SERVICE REPAIR
PROCEDURE

Freedman Seating Floor Anchorage Washer Replacement		RECALL # 10V- 253	
BY: Jose Vazquez	DEPARTMENT: Warranty	DATE: 07/26/2010	REVISION: 1

2009 Trans Tech Bus Rondak4F

Figure 1
(3 bolts on the floor pedestal)

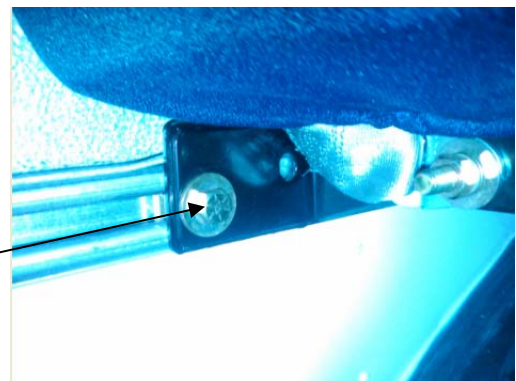
1) Locate the three 5/8" bolts underneath seat securing the seat pedestal to the floor track mounts and the two 5/8" bolts on the side wall track mount. *See Figure 1 and 2 below.*

2) Loosen the 5/8" Steel Bolt as shown below and remove the incorrect 3/8" Type A Steel Washer part number 500135. *See Figure 3.*

3) After removing the incorrect washer, install the supplied 7/16" Steel Yellow Zinc washer part number 544066. *See Figure 4.*

- 4) Tighten all five seat bolts to a torque spec of 55-60 ft*lbs.
- 5) Repeat steps 1-4 for all affected seats.
